January 2022

Dear Alissa & Council,

View Looking South from Street (Raintree Drive)

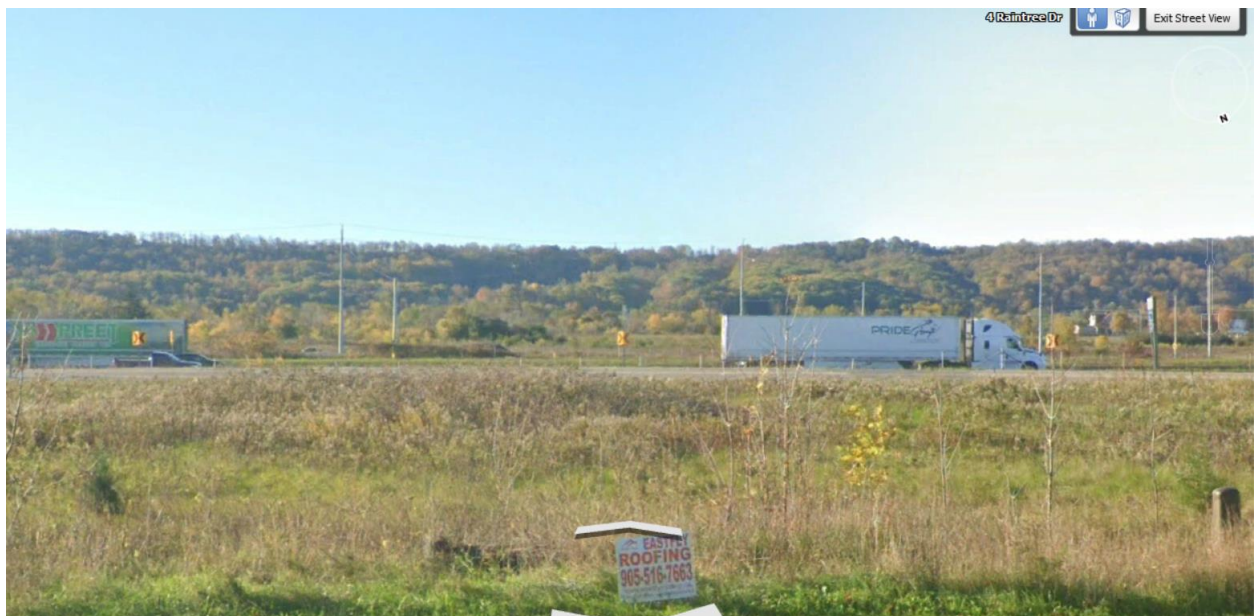
We live in a semi-detached home on Glendarling Crescent and Raintree Drive. Our home was built with a large 2nd storey veranda (pic below) which provides us with a view of the Niagara Escarpment. This veranda, and view it provides, is reflected in our property's assessment values as compared to our neighbours who do not have a Vista View Veranda. Those with a Vista View Veranda have assessment values which are on average, \$50,000 higher.

It is however my strong opinion that the higher height proposed will block my view of this UNESCO World Biosphere Reserve & will negatively impact not only me personally as the existing homeowner but also all future occupants of this home. (Mental health)

In addition, the view will be blocked for those citizens who walk, roll & ride along Baseline Road. Whether this will occur at 11 metres, or 20 metres or 33 metres is unknown. The impacts on the public realm have not been adequately assessed in my opinion.

Considering the Views / Vista planning policies contained in our Urban Hamilton Official Plan (see below), I would like to request a Visual Impact Assessment be completed **prior to considering and/or approving increasing the height by 300% on this subject land.**
